# SERVICE BULLETIN

## Product Service Bulletin ENC 15.05

Subject: **RTP Wiper Arm Replacement**

Model: Ride On Tie Plugging Machine

New Wiper Blade and Arm:

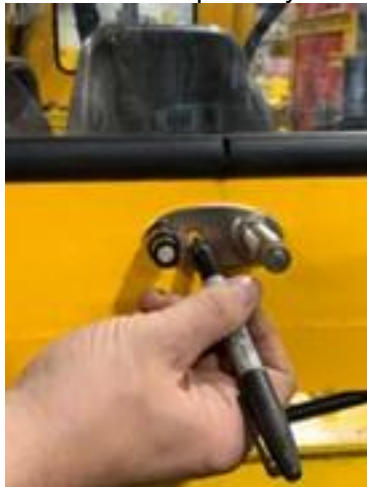
Summary: Encore is upgrading the wiper arm and blade on the front and back panels of all Ride On Tie Plugging Machine models. The new model is a more robust, heavy duty wiper arm and blade.

Step 1: Mark and center punch your hole.

Step 2: Drill a hole for a 10-24x1 counter sink socket head cap screw.

Step 3: Place your bolt through the wiper arm bracket and window panel. Tighten down bolt until wiper arm bracket is secured.

Step 4: Take your wiper arm and align holes with mounting bracket. Tighten down both bolts on wiper arm.

Step 5: Take your “J” hook and place wiper blade in bracket. Pull up to secure wiper blade to wiper arm.
